# **CONNECTION ASSESSMENT & APPROVAL PROCESS**

## **Preliminary Assessment Report For Weyerhaeuser Company Kenora Mill Project**

*CAA ID 2000-019*

Weyerhaeuser Company – Kenora Mill Project

Figure 2A. New Weyerhaeuser Connection - Preferred Alternative

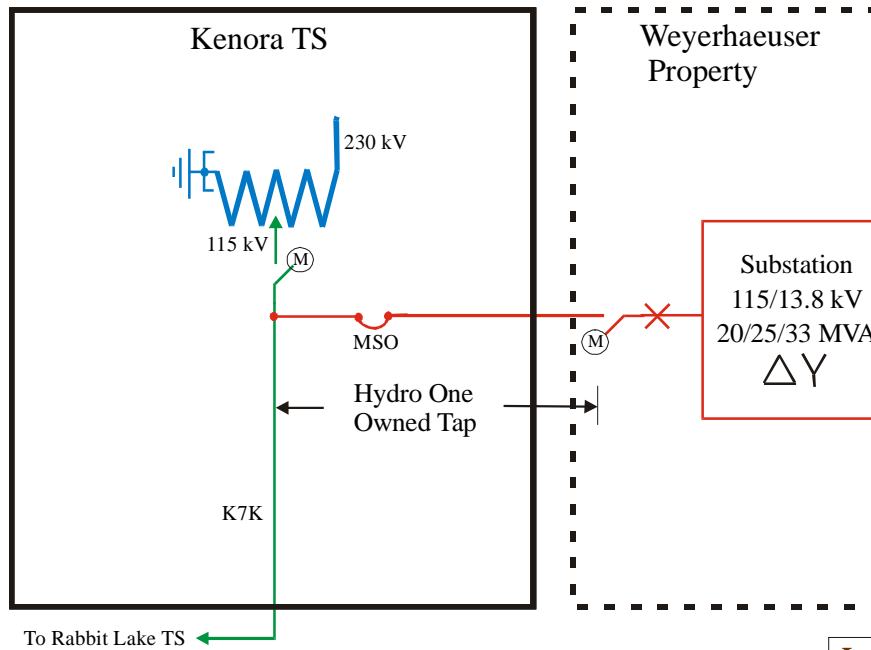
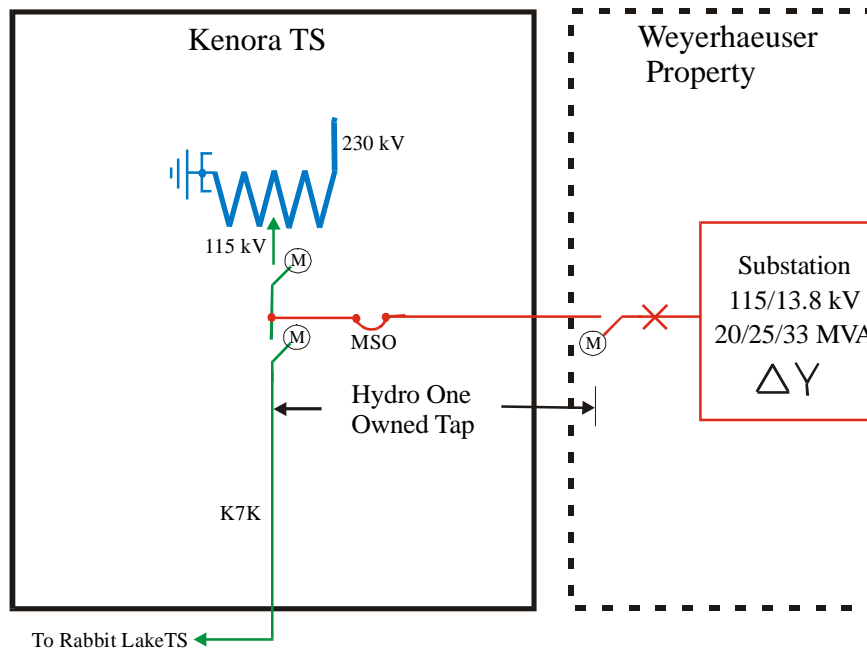
The connection applicant has proposed to connect its transformer to the 115 kV single circuit line K7K as indicated in Figure 2A. The exact location of the tap point is to be at a point adjacent to the K7K line disconnect 34-K7K, a point that is located between the disconnect switch and Rabbit Lake TS. This configuration provides a reduced of supply reliability because the power supply to the Weyerhaeuser operation is discontinued for all outages related to the 115 kV K7K circuit.

It was proposed by Hydro One that one additional disconnect switch be installed as shown in Figure 2B. This configuration would ensure continued supply of the customer load for K7K outage conditions. The connection applicant has decided, however, to keep the original connection arrangement that is shown in Figure 2A.

The connection configuration proposed by Weyerhaeuser Company meets all the requirements of the *Market Rules*.

Figure 4A. Rotor Angle Plots-Witout New Load

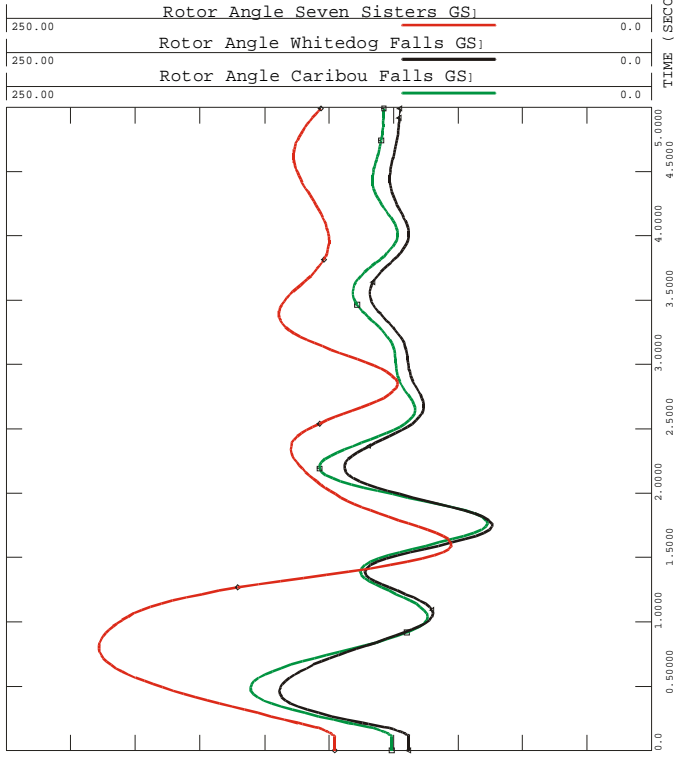
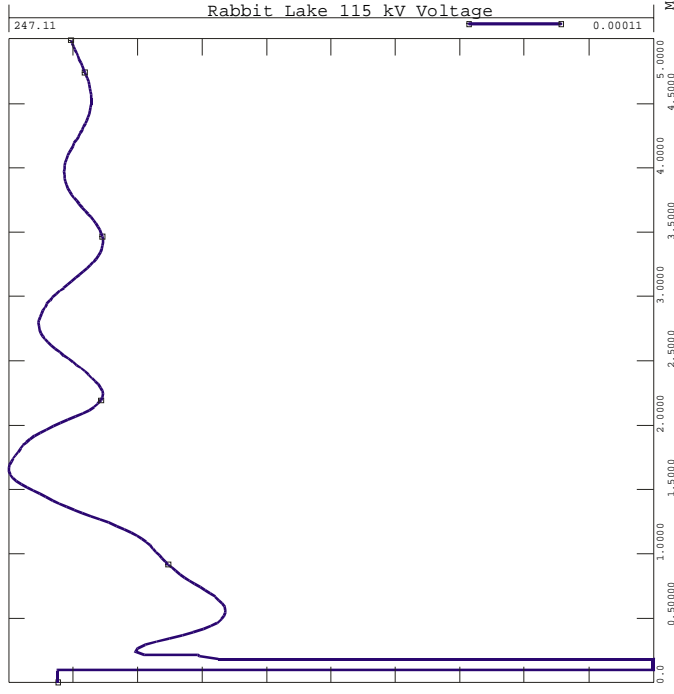
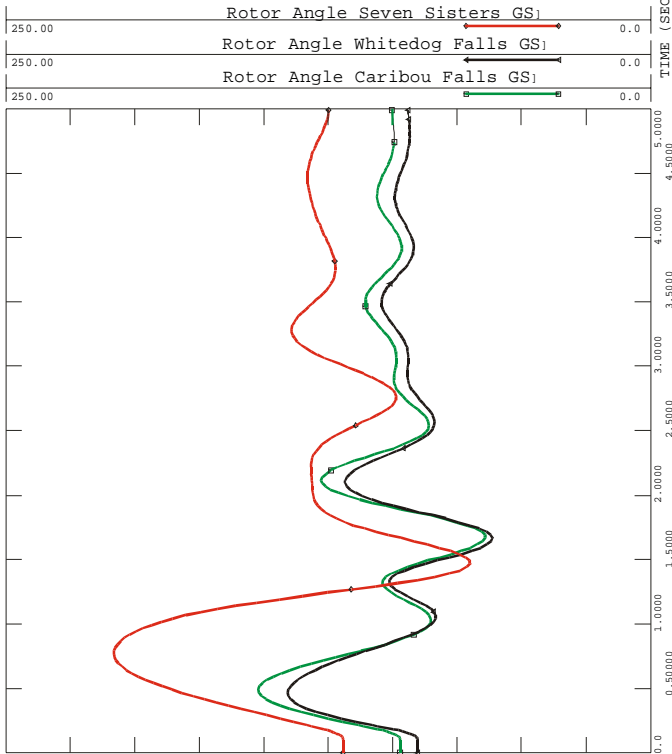
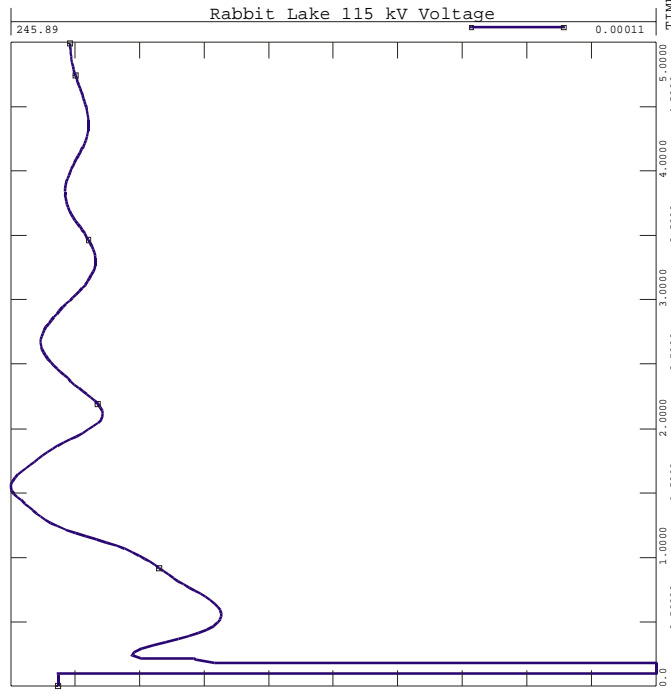
The Kenora Area Outflow was 110 MW for the case simulating the existing system configuration and 94 MW for the case with the Weyerhaeuser in service. Transient stability studies were performed for normally cleared three phase fault at Rabbit Lake TS on the 115 kV circuit K7K<sup>1</sup>. The results are plotted in Figure 3 for the study with the new load in service and Figure 4 for the existing system. For comparison purposes the figures are shown on the same page. A close look at the transient plots indicates that the transient stability behaviour is not impacted by the addition of the new load.

It should be noted that although the Kenora Area Outflow limit is lower in the case when Weyerhaeuser load is in service, the new load does not affect in any way the capability of the transmission system in the Kenora pocket or the capability of the local generation. The decrease in the maximum power that could exit the Kenora Area is a direct consequence of the increase in pocket load due to Weyerhaeuser new load.

The new Weyerhaeuser load does not have an adverse impact on the system transient stability because it does not reduce in any way the transfer capability of the system and does not limit the output of the local generation.
